RE: **Lot 23 Block 1 Unit 22 Volcano Cliffs Subd.
8004 Agua Fria Ct NW
Request for Permanent C.O. - Not Accepted
Engineers Stamp Date 5/18/16 (D10D003N23)
Certification Dated: 10/19/16**

AS BUILT
GRADING AND DRAINAGE PLAN
LOT 23, BLOCK 1, UNIT 22, VCS
ADDRESS: 8004 Agua Fria Ct NW

GRADING & DRAINAGE PLAN
8004 AGUA FRIA CT, NW
LOT 23, BLOCK 1, UNIT 22 VCS
Sheet 2 of 2

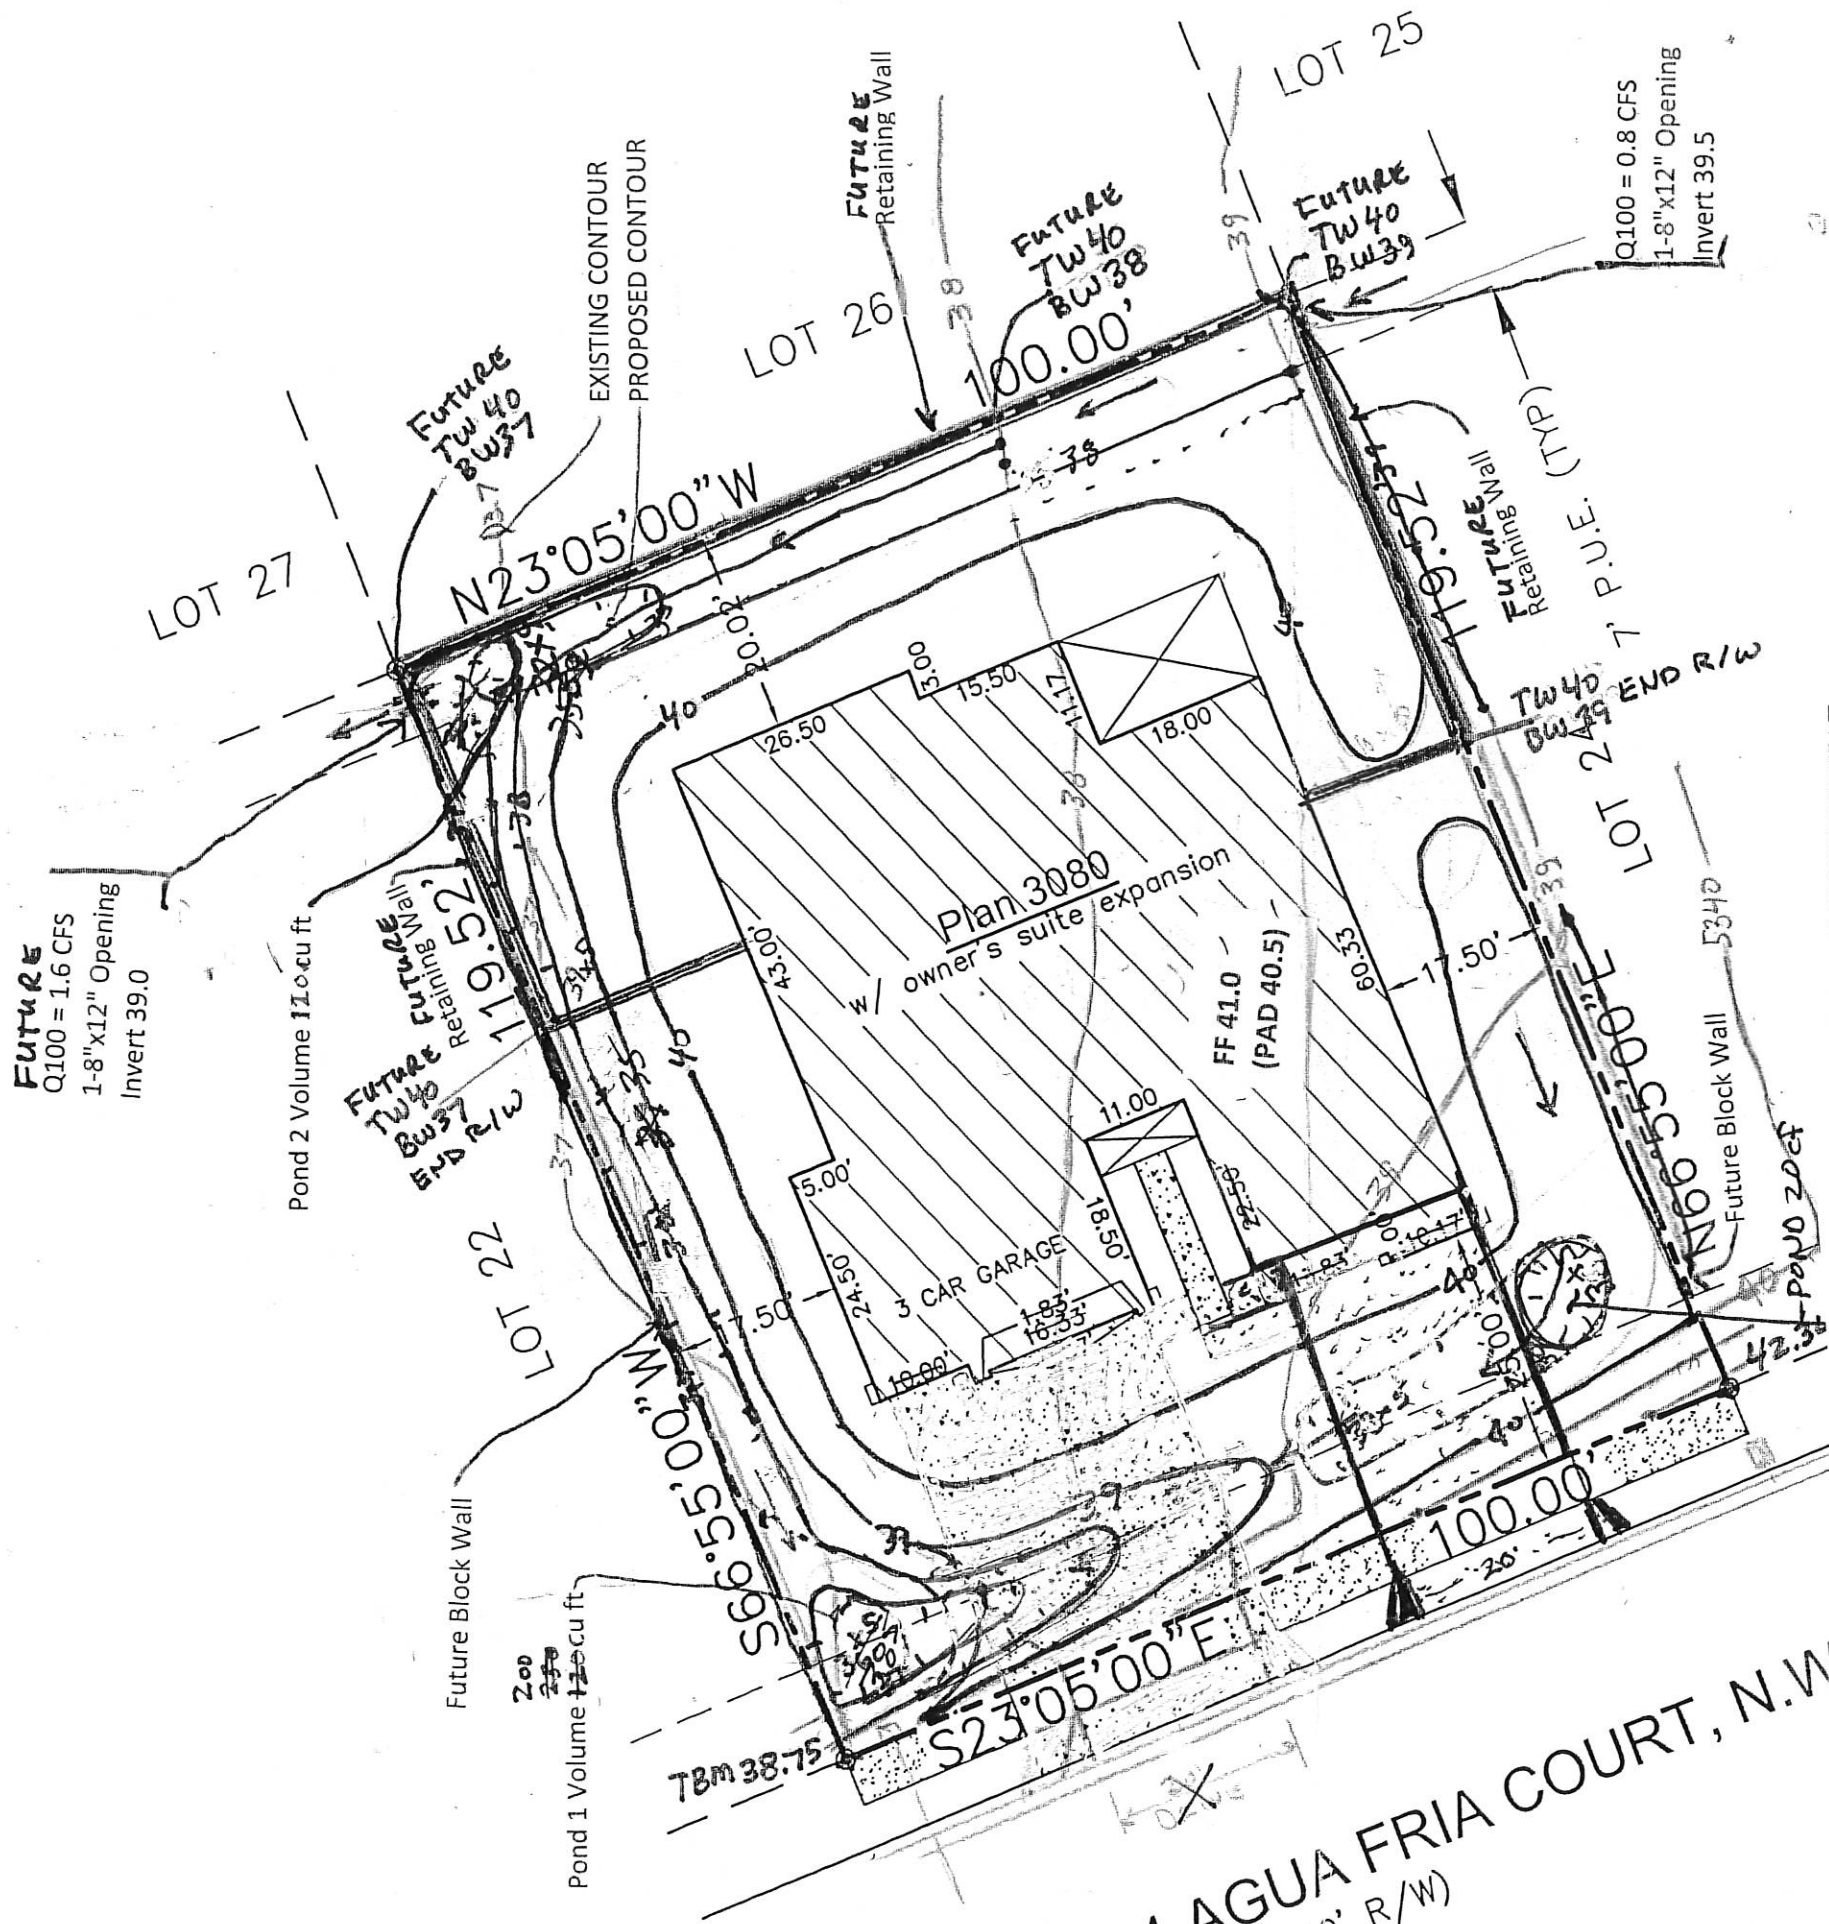
- Open trenches are filled
- Landscaping is complete
- Retaining walls with both turn block openings in backyard are missing
- Pond in NW corner of backyard is missing

An inspection by our office will need to take place after these corrects are made.
